October 13, 1995  
NG-95-2961

Subject: Duane Arnold Energy Center  
Docket No: 50-331  
Op. License No: DPR-49  
Inservice Testing (IST) Relief Request PR-07

**IES UTILITIES INC RESPONSE TO NRC  
REQUEST FOR ADDITIONAL INFORMATION ON  
DAEC IST RELIEF REQUEST PR-07**

# POINT LOCATIONS

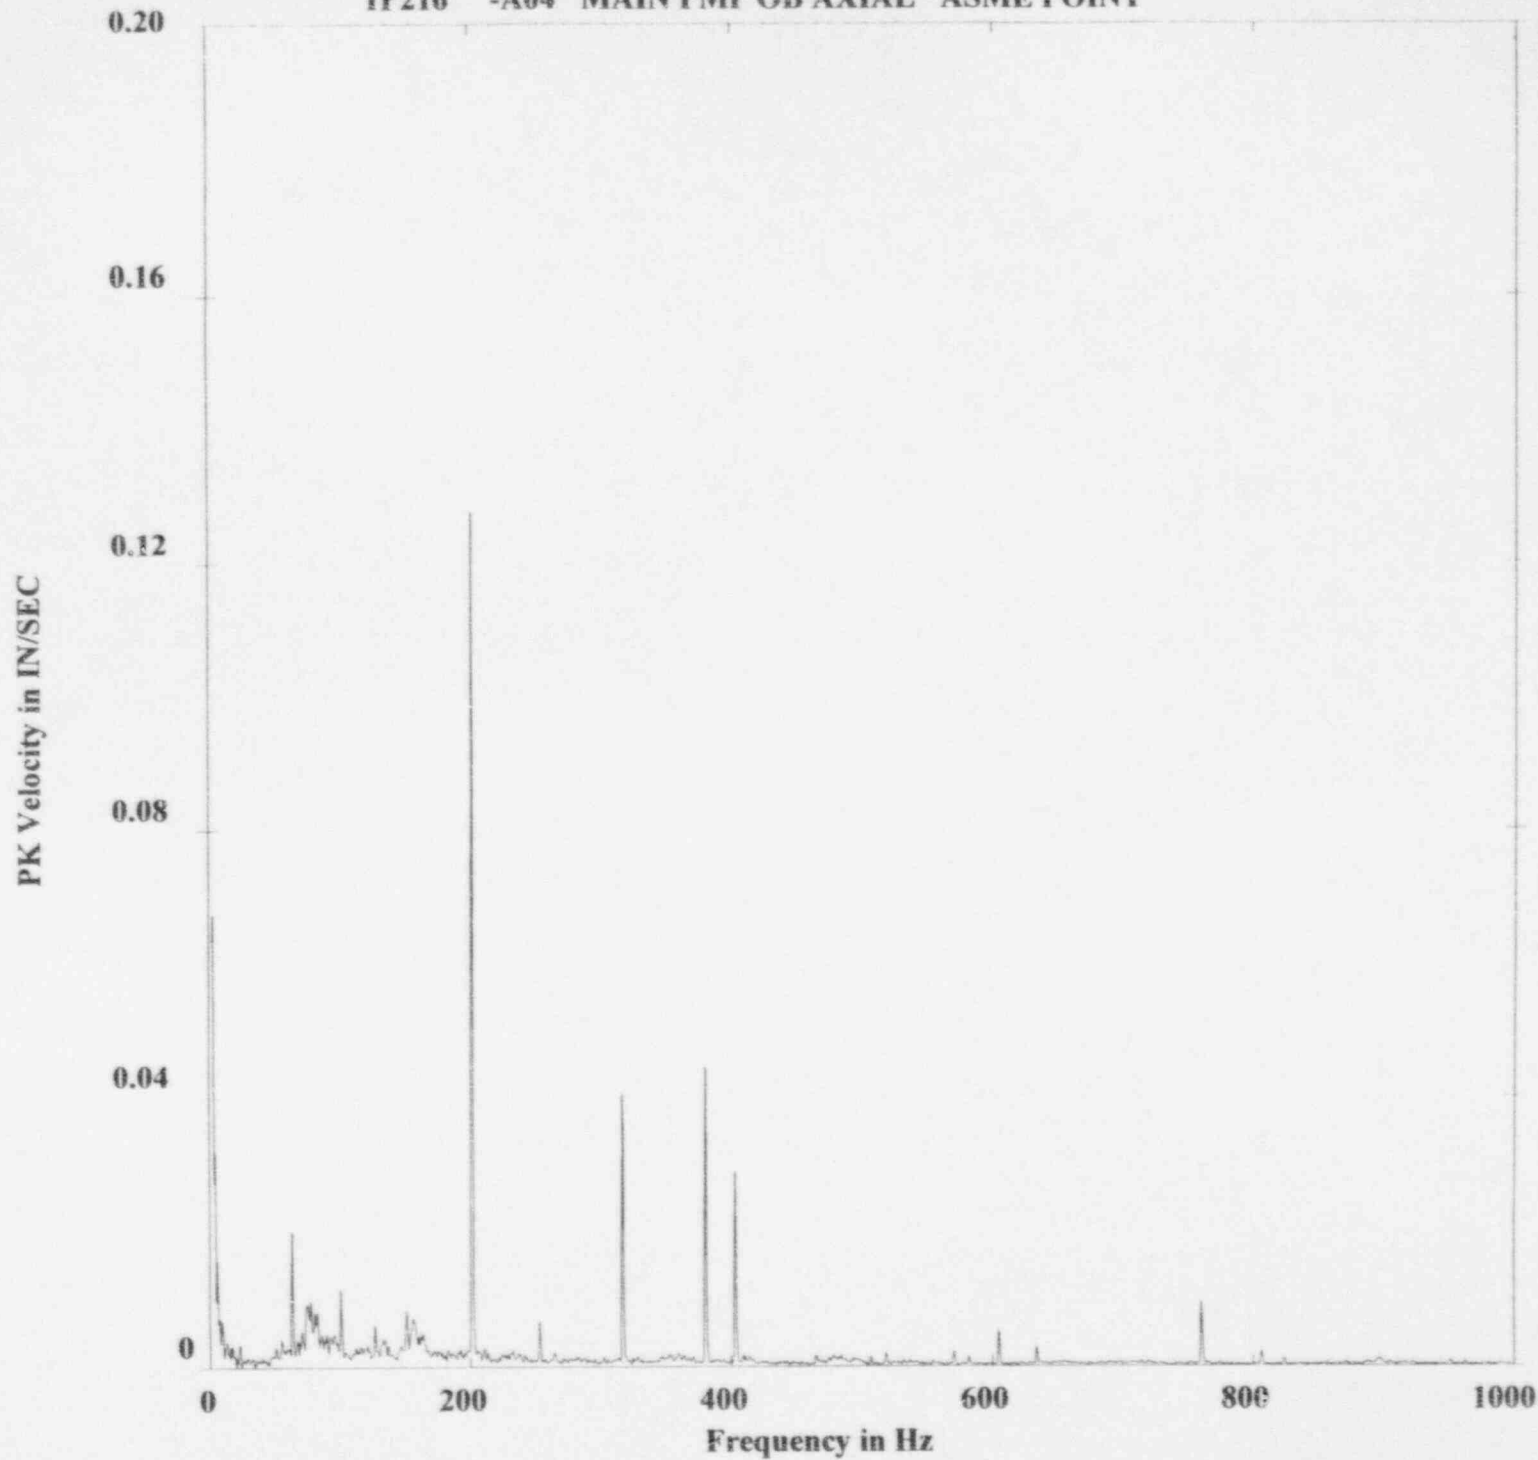
Critical bearing defect frequencies for the booster pump guide and thrust bearings are listed in the appendix (pages 34, 35) to this attachment. A diagram of the HPCI pump combination showing the vibration locations is also included in the appendix (page 12). The overall vibrational reference value at position A10 is currently 0.184 in/sec. The peaks across the vibration spectrum at this location are low, nominally 0.06 in/sec or less. Vibration levels in the Y09 and Y10 location are likewise low across the spectrum. In the horizontal direction, X09 and X10 show vane pass vibration at 201.65 Hz. The remaining peaks are overall low levels. The overall high vibration levels are not imposing a bearing concern for the booster pump. Analysis of subsynchronous vibration and running speed harmonics indicate good sleeve bearing stability and no rubs in the main pump.

Spectrum Display  
15-APR-94 09:41

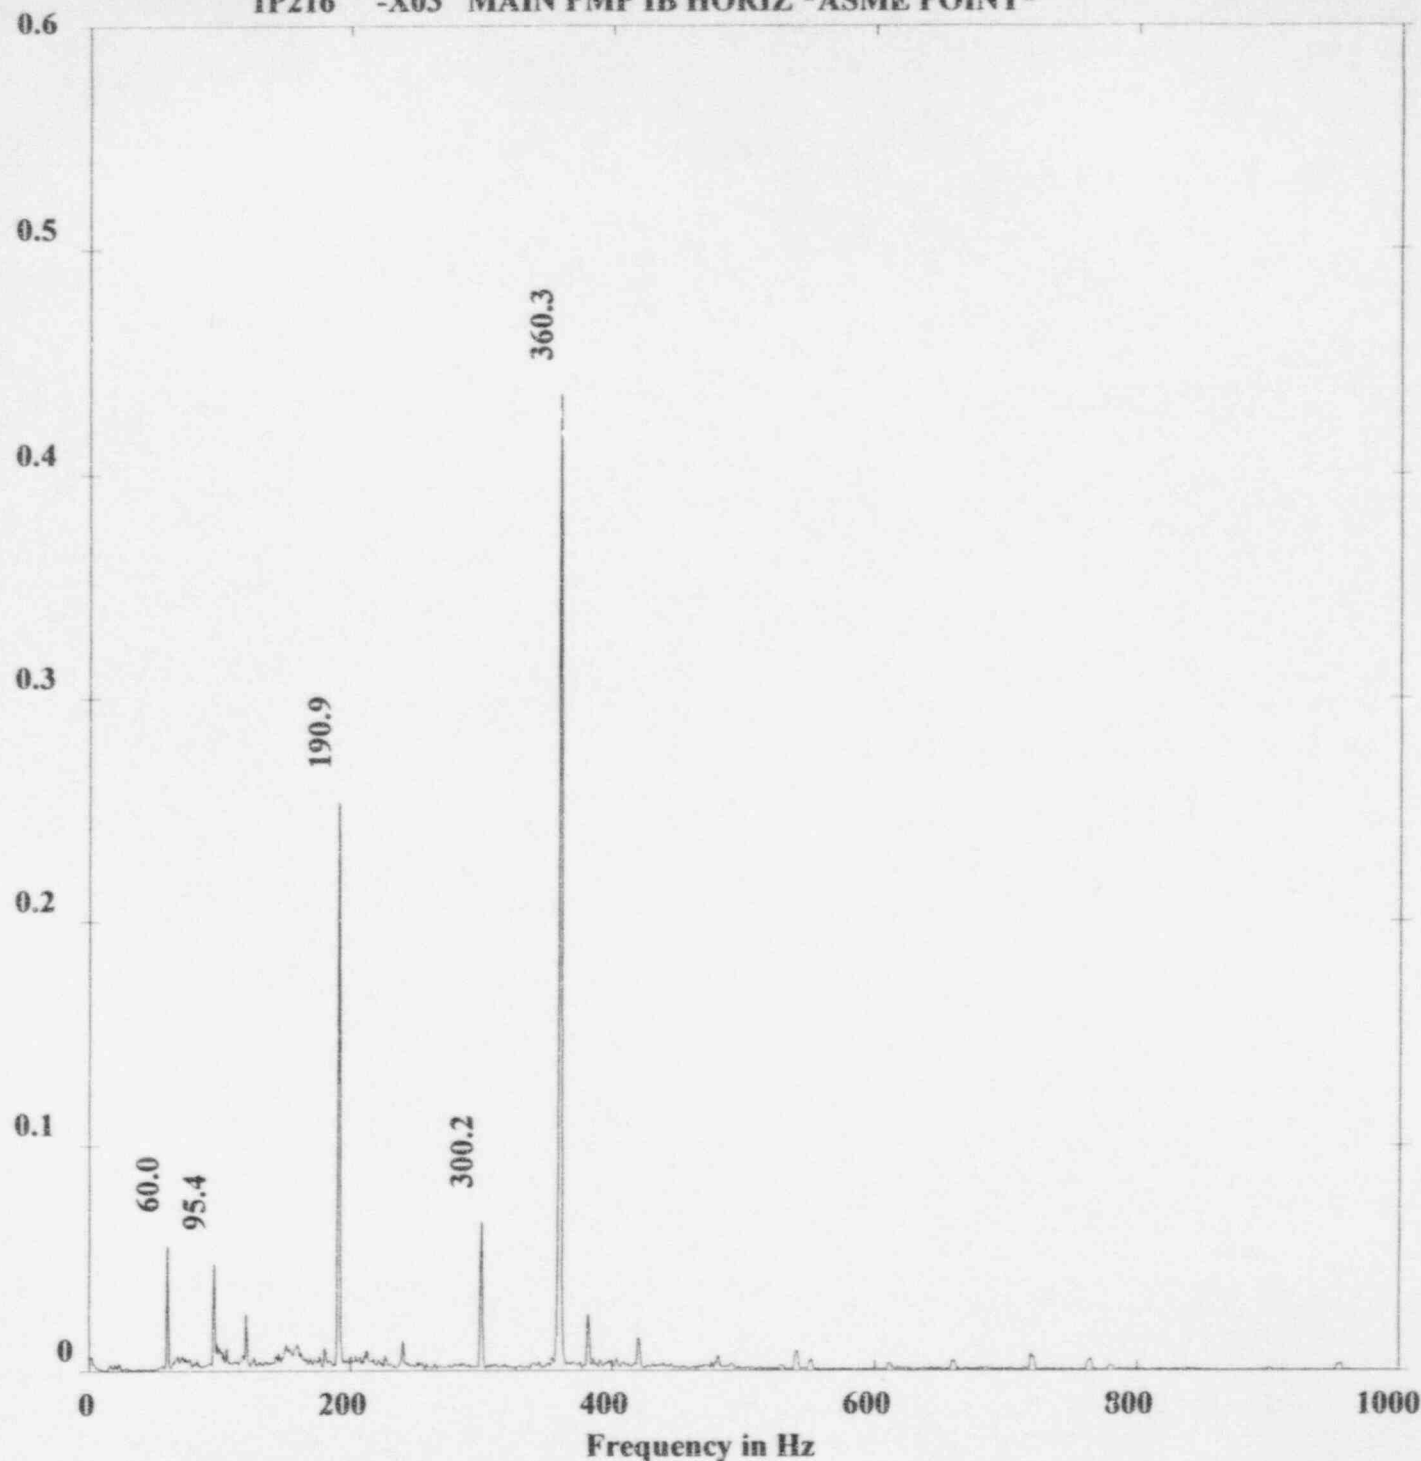
Main pump location X03 shows the highest vibration level at 3600 rpm. Constant operation at 3600 rpm is not expected during injection, pump speed is "slaved" to reactor pressure and maintaining a fixed injection rate. A spectrum plot for position X03 at 3600 rpm is included in the appendix (page 33). The major energy contributor is vane pass energy. Vane pass energy from the 4 vane booster pump is present at 190.9 Hz, or four times 2864 rpm. The main peak is at 6X running speed. Vane pass vibration from the main pump six vane impellers is amplified by the bearing housing resonance. Operation at 3600 rpm is not a concern from an operability standpoint. The pump vibration spectrum at location X03 shows low running speed and subsynchronous vibration levels and an absence of running speed harmonics. No internal degradation is occurring in the pump and good sleeve bearing stability and an absence of rubs in the main pump is indicated.
